TRANSPORT NOTE

To: **Rachel McKeown – Essex County Council**
From: **Iceni Projects (Transport)**
Date: **20th March 2024**
Title: **Response to Highway Officer Comments**

1. Iceni Projects have been appointed by Baya Group (the Applicant) to provide transportation advice regarding their development proposals on Land to the west of Clatterbury Lane, Clavering (the site). A planning application was submitted to Essex County Council (ECC) under the application reference S62A/2023/0030 for the following:

**A4. UPDATED ACCESS ARRANGEMENT WITH VISIBILITY
ASSESSMENT**

Survey Name: 24116 - Clavering ATC
Site: ATC 1
Location: Stickling Green
Date: Wed 28 Feb 2024 — Tue 05 Mar 2024

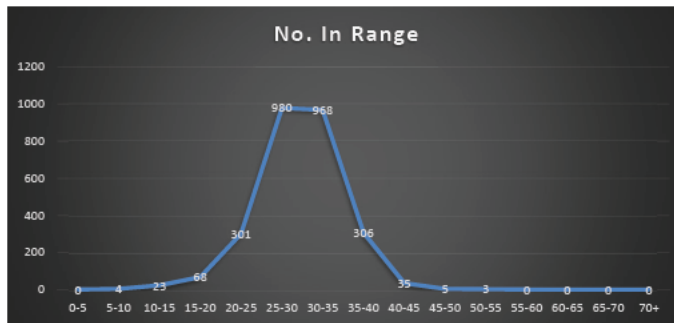
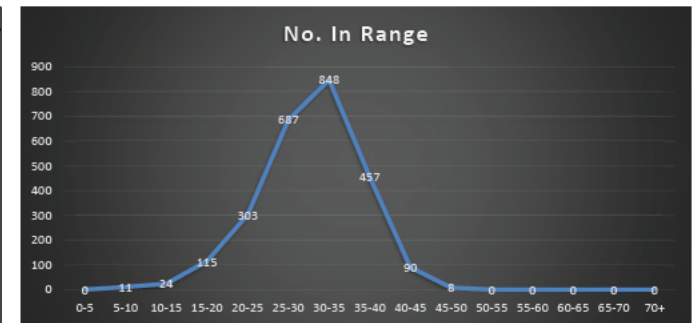
We request that a speed survey is undertaken so that the actual speed of vehicles travelling along Stickling Green is known and can be used to inform the necessary visibility splays.

Pedestrian visibility splays on B1038 are shown based on 85th percentile speeds – we would welcome submission of that traffic survey data.

16. The speed survey was conducted between 28th February 2024 and 5th March 2024, and it showed an 85th %ile speed of 34.6mph and 36.4mph in an eastern and western direction respectively, which equates to a side road visibility distance of 50.3m and 54.4m respectively. The access arrangement plan has been updated to reflect this and it shows that visibility is achievable in both directions, with the western visibility splay taken to 1m off the kerb edge, which is in accordance with draft Manual for Streets standards.

No. of Vehicles 2693
 85% Speed 34.6 MPH
 Minimum Speed 6.4 MPH
 Maximum Speed 52.8 MPH
 Average Speed 29.7 MPH

No. of Vehicles 2543
 85% Speed 36.4 MPH
 Minimum Speed 6.2 MPH
 Maximum Speed 48.5 MPH
 Average Speed 30.3 MPH

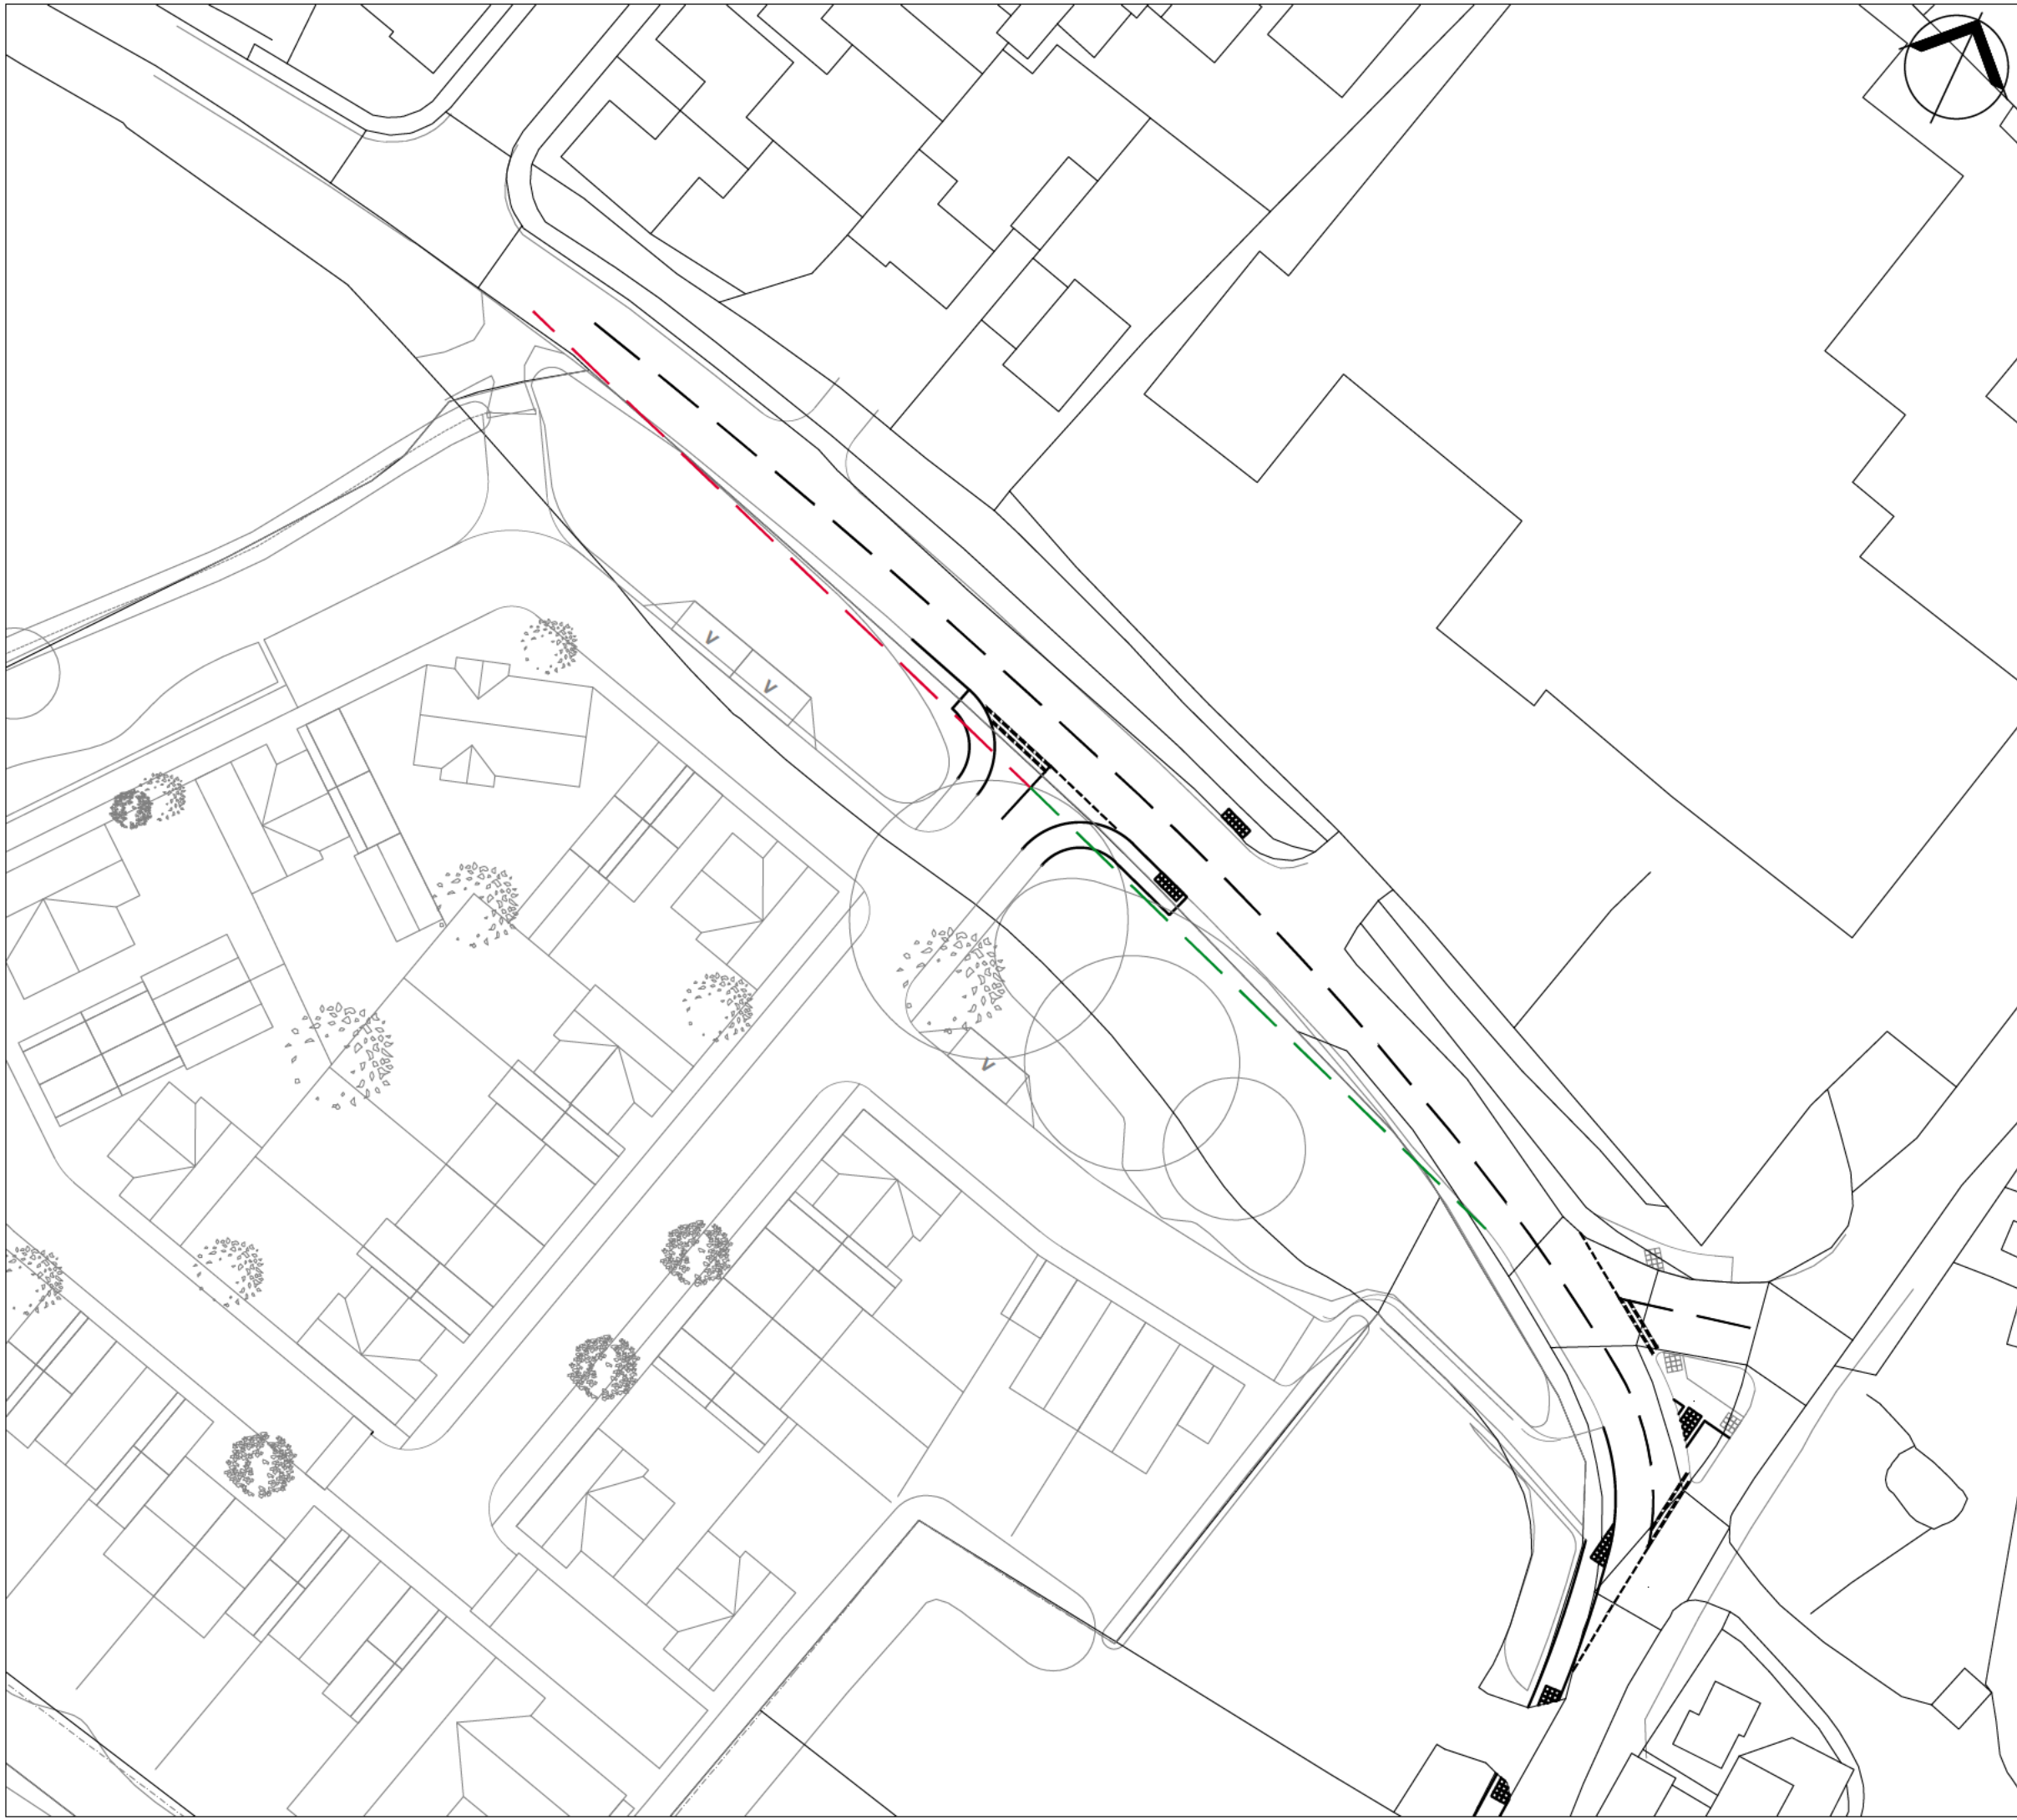
Visibility splays of 40m are achievable in both directions at the proposed vehicular access. We do not accept the applicant's reasoning that this is acceptable due to the proximity of the change to a 30mph speed limit, the access is within a 40mph area and should be designed accordingly.

We also do not accept that it is necessarily appropriate to use Manual for Street and request justification from the applicant as to why they feel it is appropriate in this context.

15. Following the meeting dated 27th February 2024, it was agreed that an ATC speed survey is completed to determine the 85th %ile speeds along Stickling Green and that the access visibility splays are amended to suit the results of the speed survey.

17. Justification for showing the visibility at 1m off the kerb can be found within the draft Manual for Streets standard which states that the *'Y distance measured from the giveway line at the centre of the minor street to a point on the outside of the likely track of a vehicle travelling along the major road. This should normally be taken as 1m out from the kerb, or the edge of the vehicle track if there is no kerb (for example where there are longitudinal parking bays along the edge of the vehicle track).'*

18. However, due to inconsistencies with various county design guides, it was removed from the final release of MfS in which paragraph 7.7.3 states *“The Y distance represents the distance that a driver who is about to exit from the minor arm can see to his left and right along the main alignment. For **simplicity**, it is measured along the nearside kerb line of the main arm, although **vehicles will normally be travelling a distance from the kerb**” (Iceni underlining/bold)*

19. As such, it is clearly stated within the evolution of Manual for Streets that 1m off the kerb edge is an accepted point for the Y measurement supported by the research to produce Manual for Streets.

20. Full outputs of the traffic survey data can be found within **Appendix A3**, with the updated drawing found within **Appendix A4**.

KEY:
 2.4M X 50.3M JUNCTION VISIBILITY SPLAY (BASED ON AN 85th %ILE ROAD SPEED OF 34.6MPH)
 2.4M X 54.4M JUNCTION VISIBILITY SPLAY (BASED ON AN 85TH %ILE ROAD SPEED OF 36.4MPH) (1M OFFSET FROM KERB EDGE)

**A6. UPDATED PEDESTRIAN CROSSING VISIBILITY ASSESSMENT
(STICKLING GREEN)**

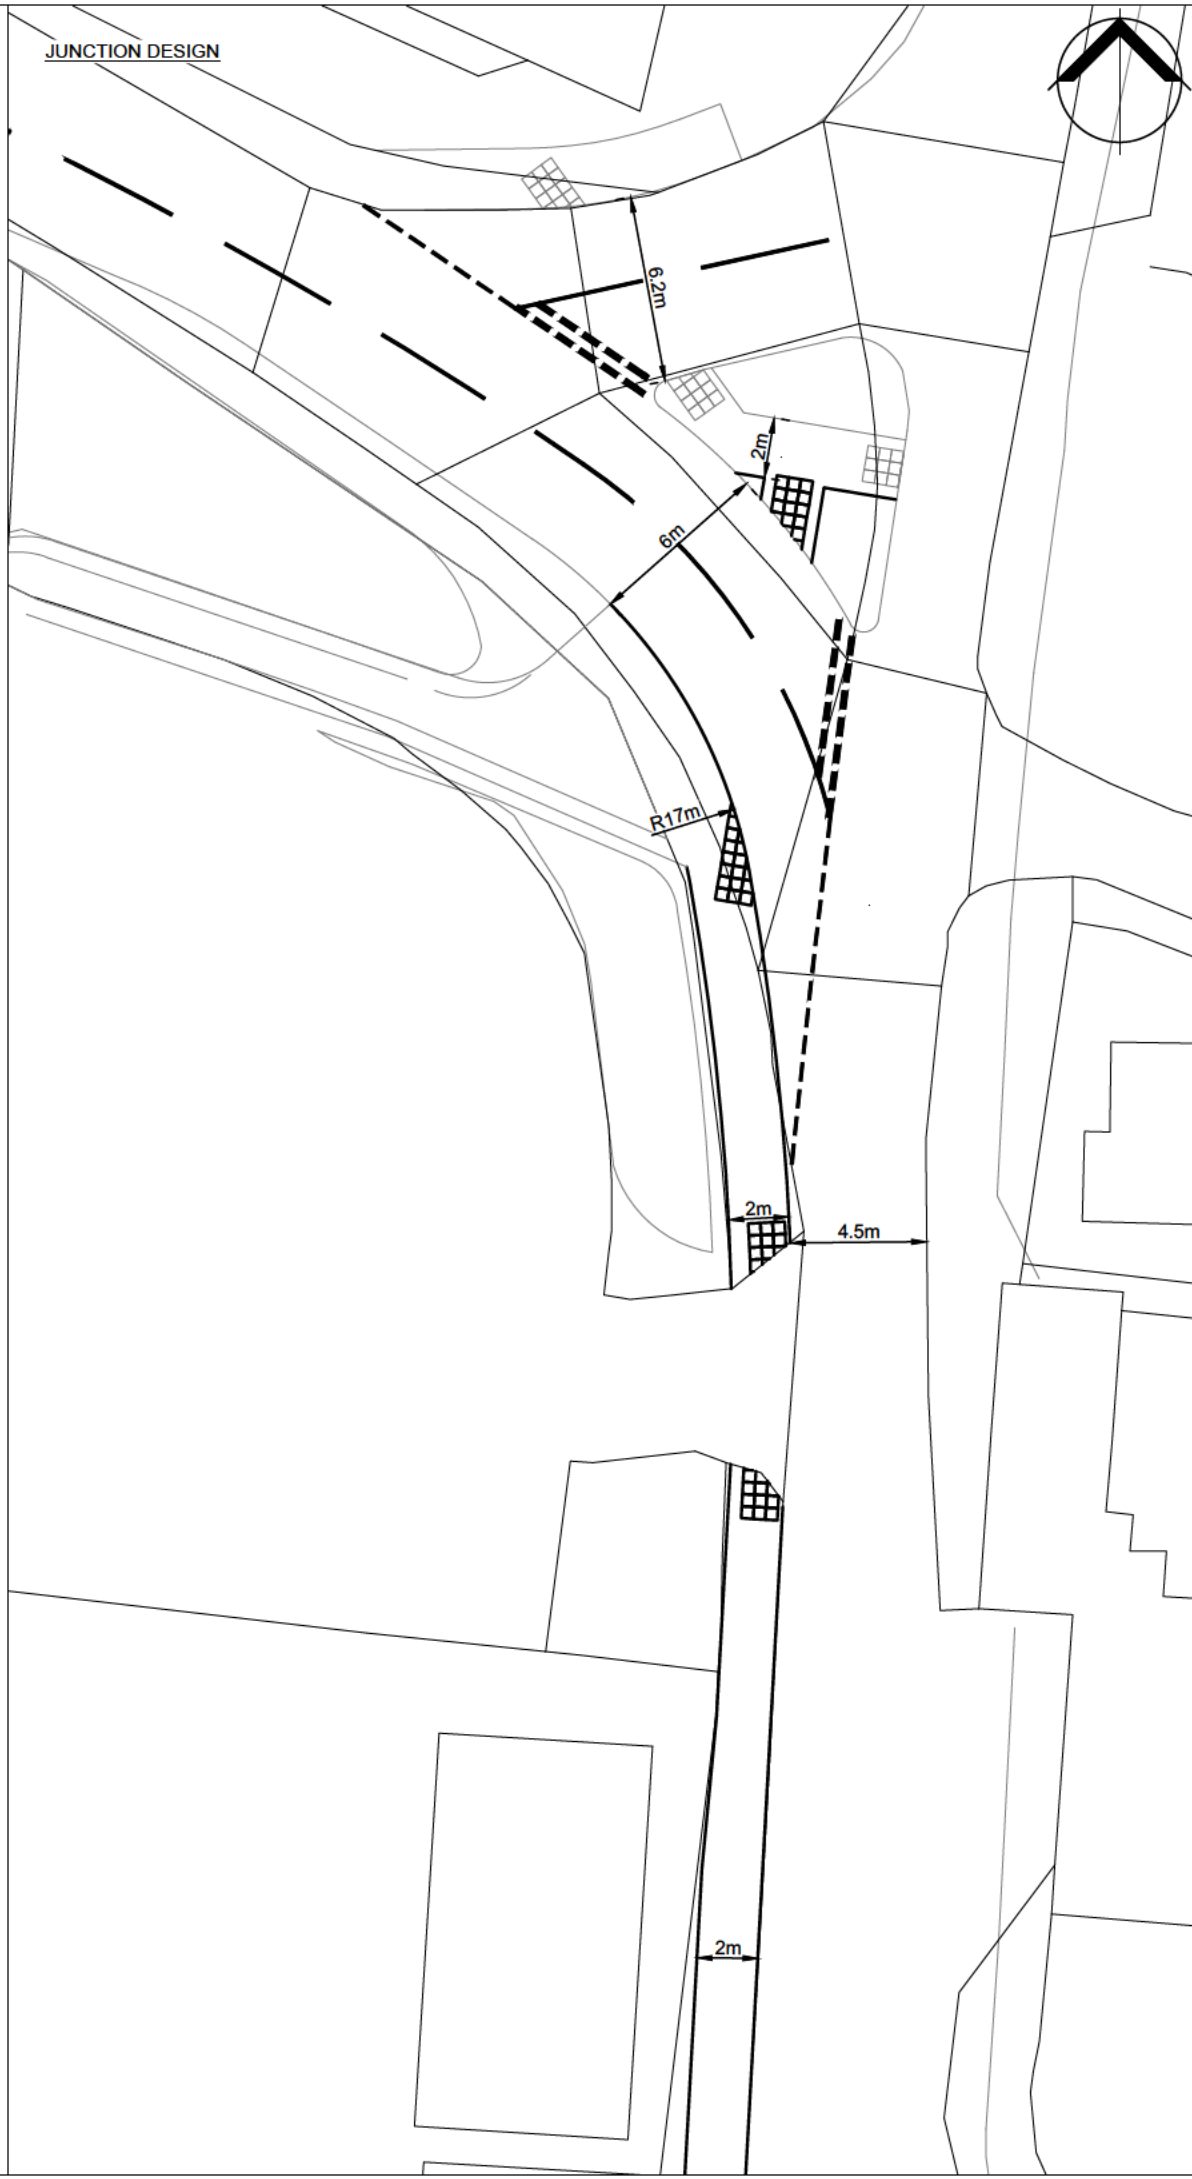
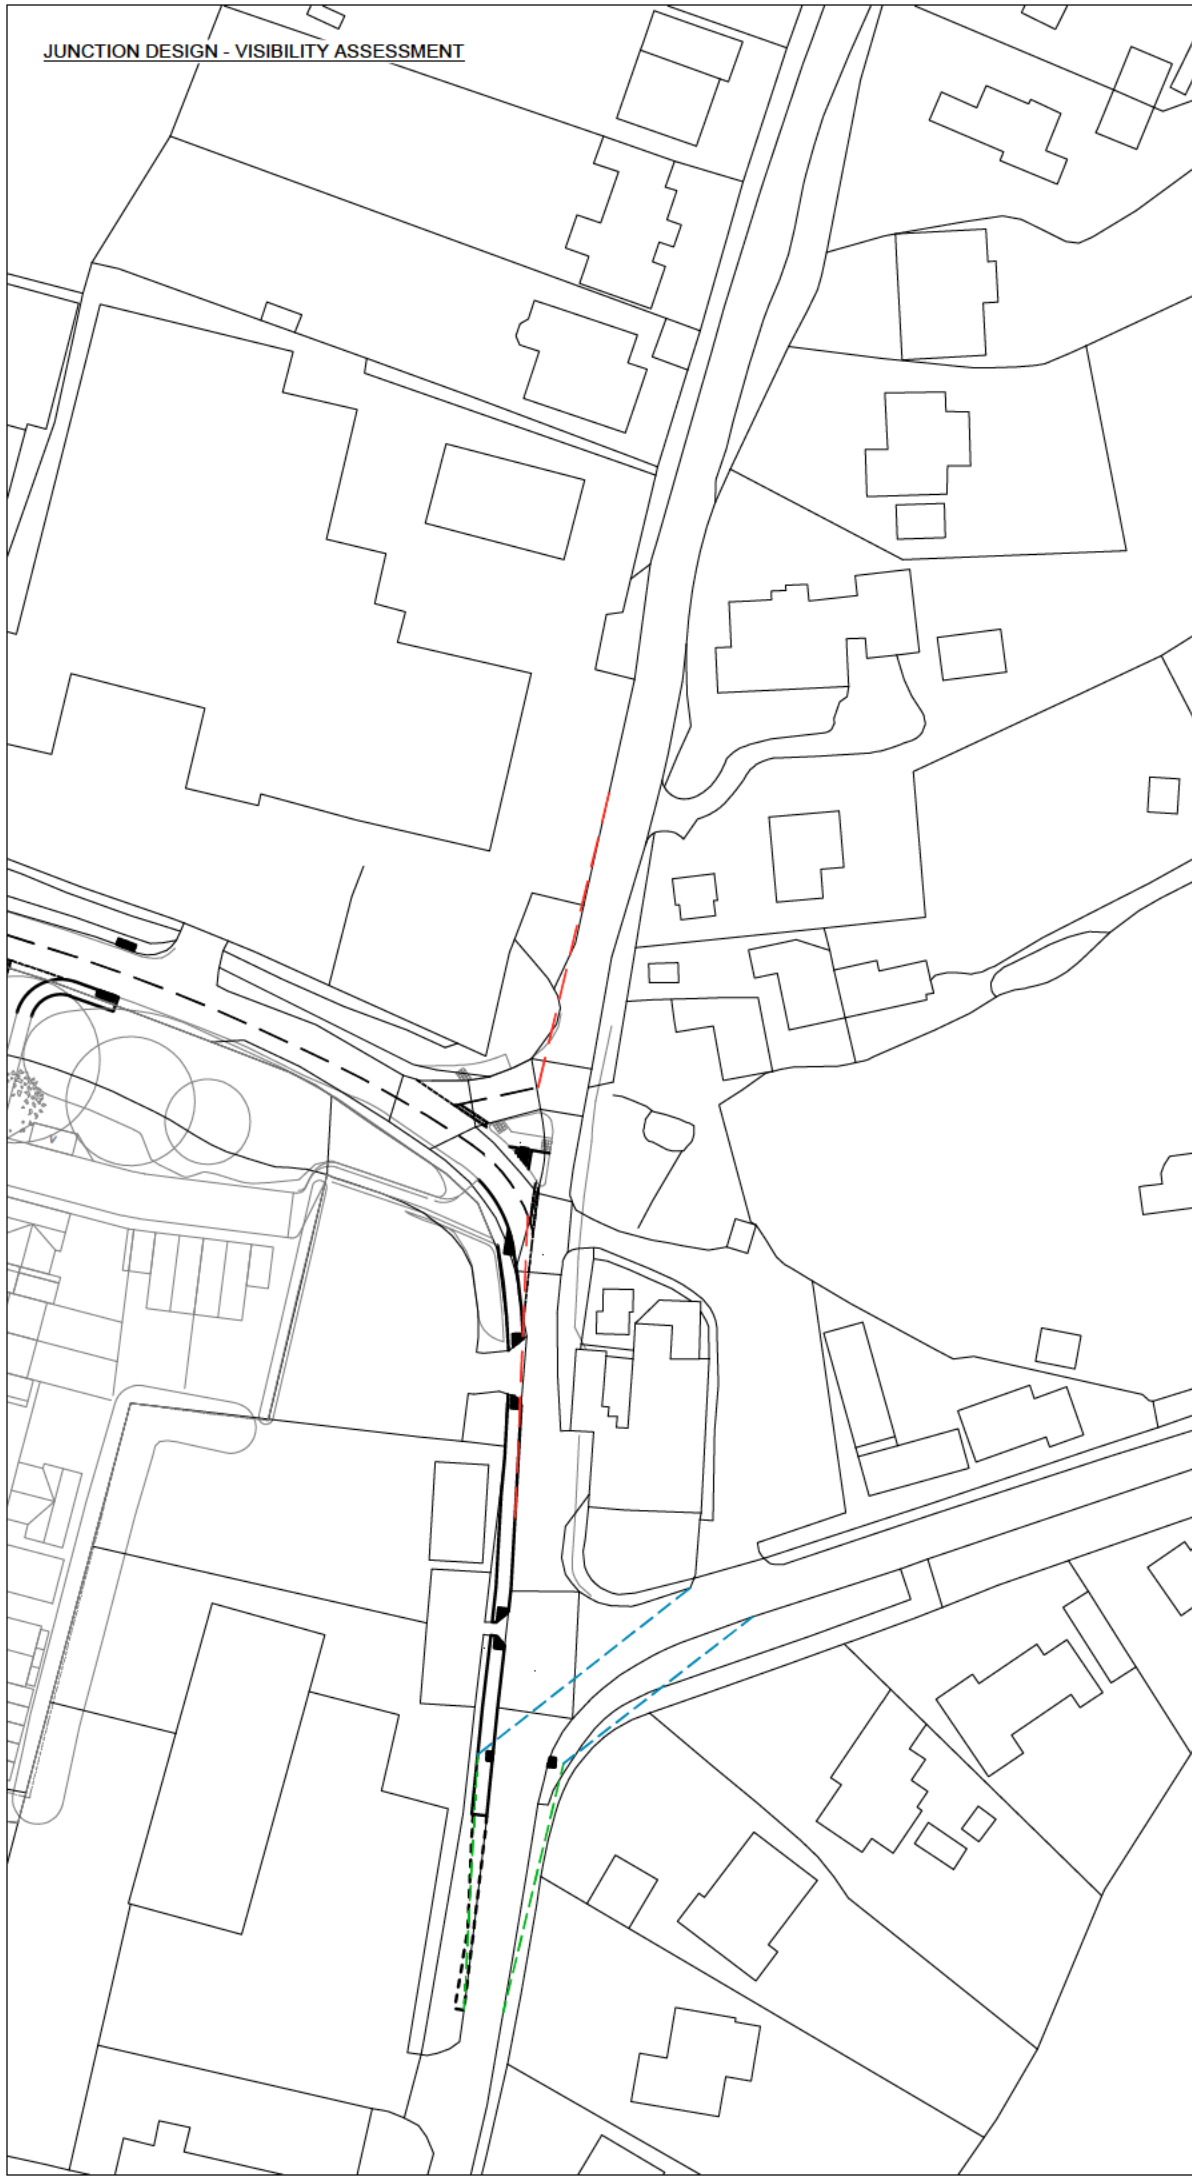
Pedestrian visibility splays are shown based on 'road speed of 30mph' however, not all of the pedestrian crossing points shown are within the signed 30mph limit.

25. Following receipt of the 85th percentile speeds, the pedestrian visibility splays on Stickling Green have been updated to the actual speed of the road which was also used for the access visibility splays. The pedestrian visibility splays are also shown to 1m off from the carriageway.

26. The updated drawing can be found within **Appendix A6**.

- - - - - 1.5M X 40M PEDESTRIAN VISIBILITY SPLAY WITH 1M OFFSET (BASED ON A ROAD SPEED OF 30MPH AS PER MFS STANDARDS AND TRAFFIC SIGNS MANUAL CHAPTER 6 STANDARDS)
- - - - - 2.4M X 50.3M JUNCTION VISIBILITY SPLAY WITH 1M OFFSET (BASED ON AN 85TH %ILE ROAD SPEED OF 34.6MPH)
- - - - - 2.4M X 54.4M JUNCTION VISIBILITY SPLAY WITH 1M OFFSET (BASED ON AN 85TH %ILE ROAD SPEED OF 36.4MPH)
- - - - - 2.4M X 54.4M JUNCTION VISIBILITY SPLAY TO CENTRE LINE (BASED ON AN 85TH %ILE ROAD SPEED OF 36.4MPH)
